Addendum to Work Plan for Site Assessment and Preferential Pathway Survey
Former Chevron Service Station No. 9-9708
5910 MacArthur Boulevard
Oakland, California
Fuel Leak Case No. RO0000124

Subject: Conditional Approval of Work Plan, Fuel Leak Case No. RO0000124 (Global ID # T0600102093), Chevron #9-9708, 5910 MacArthur Boulevard, Oakland, 94605

FIGURE
2

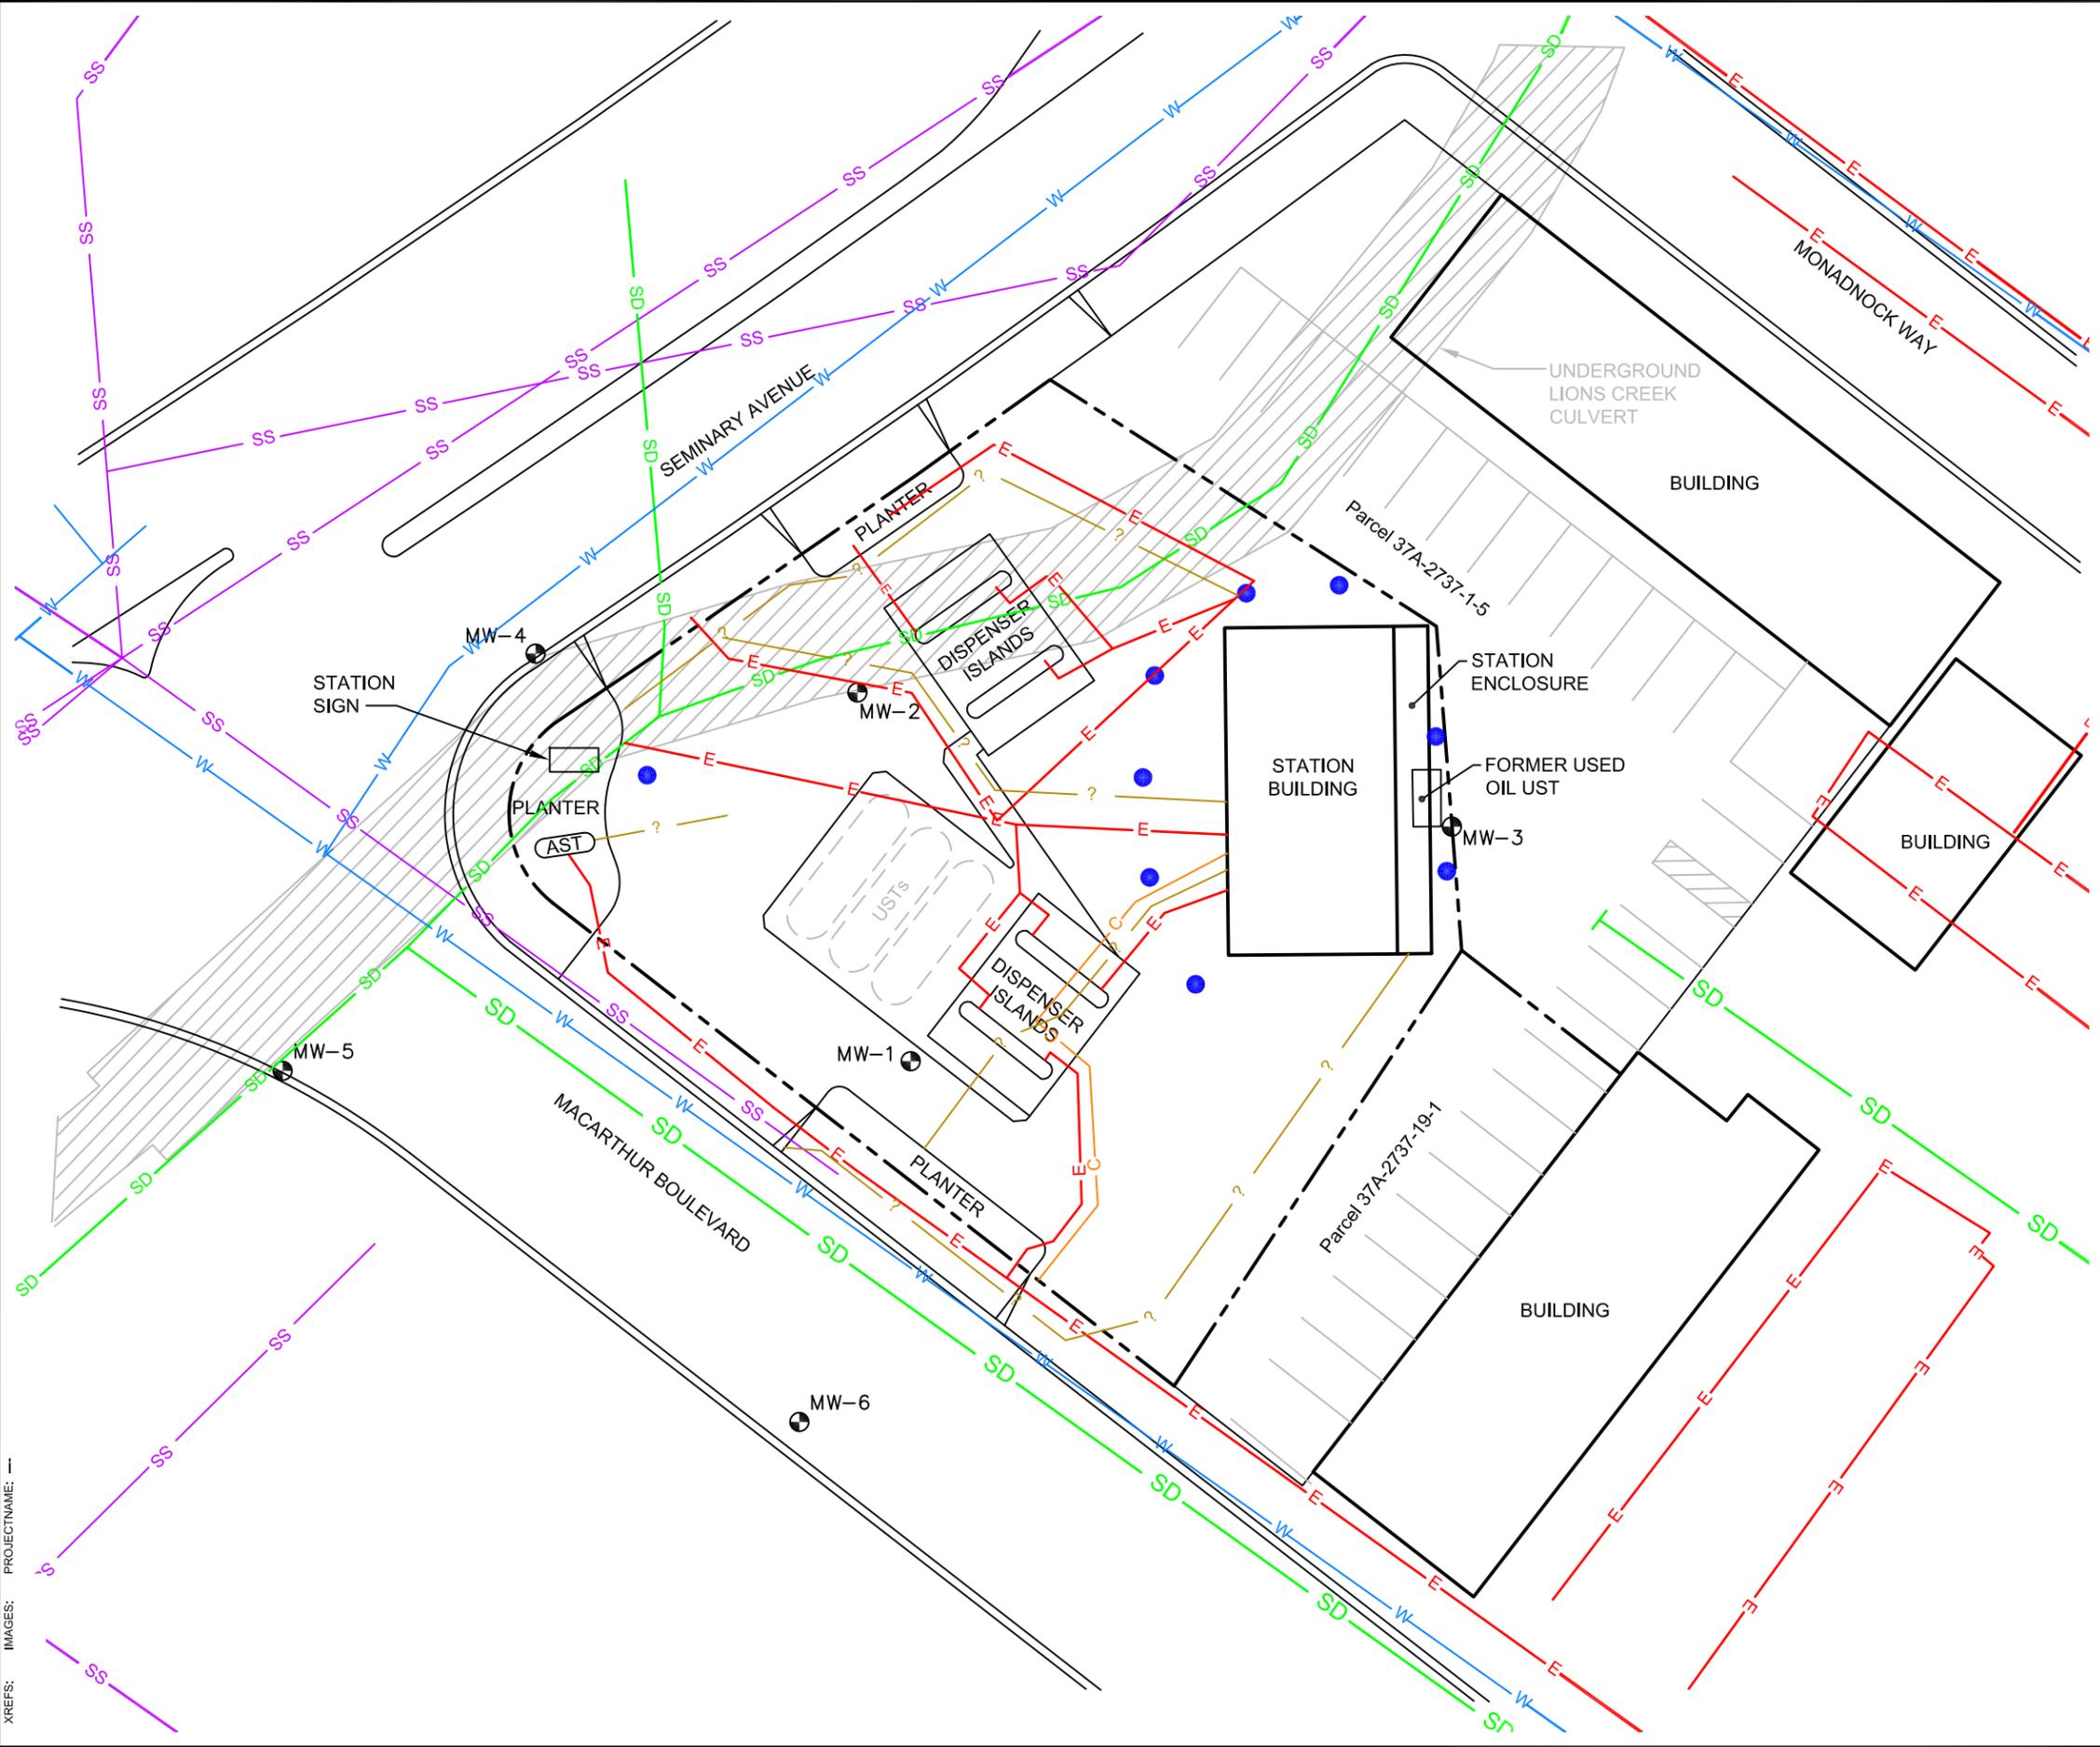
- Include two additional soil borings upgradient of the former waste oil underground storage tank (UST);
- Collect and analyze additional soil samples at signs of contamination (odor, discoloration, Photoionization Detector (PID) readings, etc.); and
- Clear each soil boring with a hand auger in order to collect shallow soil samples.

- a. **Request for Two Additional Soil Bores** – ACEH is in general agreement with the location of the proposed soil bores at the subject site; however, requests the addition of two soil bores slightly upgradient of the former waste oil UST location. This will address data gaps associated with this presumed source location (lateral and vertical delineation in soil) and can provide data on the potential for offsite upgradient sources. The collection of soil and grab groundwater at both locations can use protocols proposed in the work plan, as modified below. ACEH requests the submittal of a work plan addendum (Figure 2 only) with the locations of the additional soil bores noted, by the date identified below.

ARCADIS concurs with the ACEH's modifications to the work plan and has included a revised Figure 2 which illustrates the additional soil boring locations. A hand auger

The revised Figure 2 also illustrates the utilities found during the onsite preferential pathway survey. ARCADIS will include the results of the well survey and utility survey in the soil and groundwater investigation report.

The locations of the additional soil borings are in close proximity to the property line, and therefore, it may be necessary to install the soil borings on the neighboring, off-site, property (Figure 2). Prior to the advancement of the soil borings, ARCADIS proposes to conduct a site survey to establish property line boundaries. Once the property boundaries have been marked, ARCADIS will be able to evaluate if the additional boring locations are within on-site property boundaries. If they are located off-site, it will be necessary to obtain appropriate access with the adjacent property owner(s). Every effort will be made to install the borings on-site, without compromising their locations relative to the former waste oil tank.
